Acceptance report, control cabinet, MA-01

对象 Subject	1 台控制柜，1200 × 800 × 300 毫米，带控制器 1 control cabinet, 1200 × 800 × 300 mm, with controller
委托方 Client	Muster Maschinenbau GmbH (虚构)
制造商 Manufacturer	Przykład Sp. z o.o. (虚构)
地点和日期 Place and date	视频预约，波兹南工厂，04.03.2026 Video appointment, plant in Poznań, 04.03.2026
依据 Basis	订单、电路图 D 版、布置图、零件清单 Order, wiring diagram revision D, layout drawing, parts list
在场人员 Present	制造商项目负责人和装配人员，Office-Remscheid Manufacturer's project lead and fitter, Office-Remscheid

A2 门内电路图为 C 版，订购的是 D 版
Wiring diagram in the door: revision C, ordered revision D

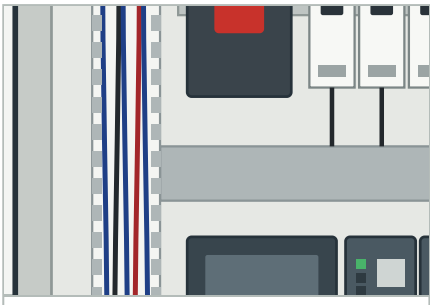
编号	检查项和结果 Item and finding	结果 Result
文件 Documents		
A1	铭牌已安装且完整 铭牌已安装，内容完整 Rating plate fitted, details complete	**合格** OK
A2	柜内电路图与订购版本一致 门内电路图为 C 版，订购的是 D 版 Wiring diagram in the door: revision C, ordered revision D	**提示** Note
A3	零件清单：抽查 10 个器件 10 个器件全部一致 10 of 10 devices match	**合格** OK
A4	有制造商的测试记录 有已签字的记录，副本见附件。未评价内容 Available and signed, copy attached. Content not assessed	**合格** OK
装配 Assembly		
B1	尺寸和颜色与订单一致 1200 × 800 × 300 毫米，由制造商测量。标签颜色为 RAL 7035 1200 × 800 × 300 mm, measured by the manufacturer. Colour according to label RAL 7035	**合格** OK

B3 左侧线槽没有盖
Left cable duct has no cover

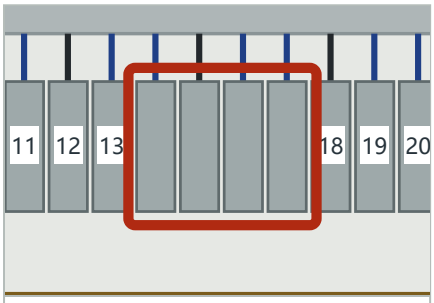
编号	检查项和结果 Item and finding	结果 Result
B2	柜体和漆面无可见损伤 未见损伤，视频中展示了所有侧面 No damage visible, all sides shown on video	**合格** OK
B3	所有线槽都有盖 左侧线槽没有盖 Left cable duct has no cover	**未完成** Open
B4	器件标识清晰 抽查的器件均有标识 All devices in the sample are labelled	**合格** OK
B5	柜体上未用的孔已封闭 底部缺少一个 M25 堵头 One M25 blanking plug missing in the base	**未完成** Open
接线 Wiring		
C1	端子有标签 14 至 17 号端子缺少标签 Labels missing on terminals 14 to 17	**未完成** Open
C2	线号：抽查 20 根线 20 根线全部与电路图 D 版一致 20 of 20 wires as in wiring diagram revision D	**合格** OK
C3	保护导体已接到 PE 排 可见所有保护导体均接到 PE 排 All protective conductors visibly connected to the PE bar	**合格** OK
C4	柜门已接保护导体 导线已安装，两端均已连接 Conductor fitted and connected at both ends	**合格** OK
制造商演示 Demonstration by the manufacturer		
D1	控制电压，记录制造商的读数 24.1 V DC，由制造商测量 24.1 V DC, measured by the manufacturer	**合格** OK
D2	输入输出：查看 12 个信号 12 个信号均在显示中看到 12 of 12 signals seen on the display	**合格** OK
D3	演示急停回路 未演示，按钮未连接 Not demonstrated, the button was not connected	**未演示** Not demonstrated

编号	检查项 Item	制造商答复 Manufacturer's reply	期限 by
B3	左侧线槽没有盖 Left cable duct has no cover	盖已裁好，测试后装上 Cover is cut to size and will be fitted after the test	06.03.2026
B5	底部缺少一个 M25 堵头 One M25 blanking plug missing in the base	堵头有库存，将装上 Plug is in stock and will be fitted	06.03.2026
C1	14 至 17 号端子缺少标签 Labels missing on terminals 14 to 17	标签将重新打印 Labels will be reprinted	06.03.2026
